Access Compliance Report
Public Rights-of-Way
(Curb Ramps)

Intersection ID: 46733	Main Street: DARCY_HOPKINS_DR	Cross Street: BEAVER_BROOK_WY	Location:	SE
ADA ID: 85044475A133	Ramp Type: Perp	Initial Pass/Fail: Pass	Overall Compliance: No	Severity Score: 10

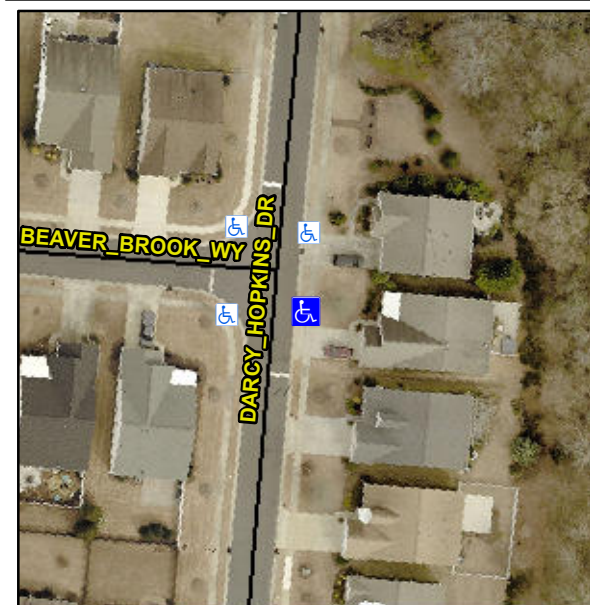
Not Found, R304.2.2-Perp, R304.3.2-Para, R305

Compliance	Description	Data	Compliance	Description	Data
N/A	Ramp Length (in)	48.0	Yes	Ramp Slope (%)	6.3
Yes	Ramp Width (in)	48.0	Yes	Ramp XSlope (%)	0.3
N/A	Flare Type LT	Sloped	N/A	Flare Type RT	N/A
N/A	Flare Slope LT (%)	7.3	Yes	Flare Slope RT (%)	6.1
N/A	Flare Traversable LT?	Yes	N/A	Flare Traversable RT?	Yes
Yes	Landing Length (in)	48.0	No	DWS Provided?	No
Yes	Landing Width (in)	48.0	N/A	DWS Contrast?	No
No	Landing Slope (%)	3.2	N/A	DWS Length (in)	N/A
Yes	Landing X Slope (%)	0.8	N/A	DWS Full Width?	No
N/A	Landing Curb? (Y/N)	No	N/A	DWS Offset (in)	N/A
N/A	Shared Landing?	No			
Yes	Gutter Ponding?	No	Yes	Gutter Slope (%)	1.2
Yes	Gutter Lip Ht (in)	0.0	Yes	Gutter X Slope (%)	1.0
N/A	Painted X Walk1?	No	N/A	Painted X Walk2?	N/A
	X Walk 1 Direction	To NW		X Walk 2 Direction	N/A
N/A	X Walk 1 Width (in)	N/A	N/A	X Walk 2 Width (in)	N/A
	X Walk 1 Slope (%)	3.6		X Walk 2 Slope (%)	N/A
	X Walk 1 X Slope (%)	0.2		X Walk 2 X Slope (%)	N/A

Remove & Replace Entire Ramp.
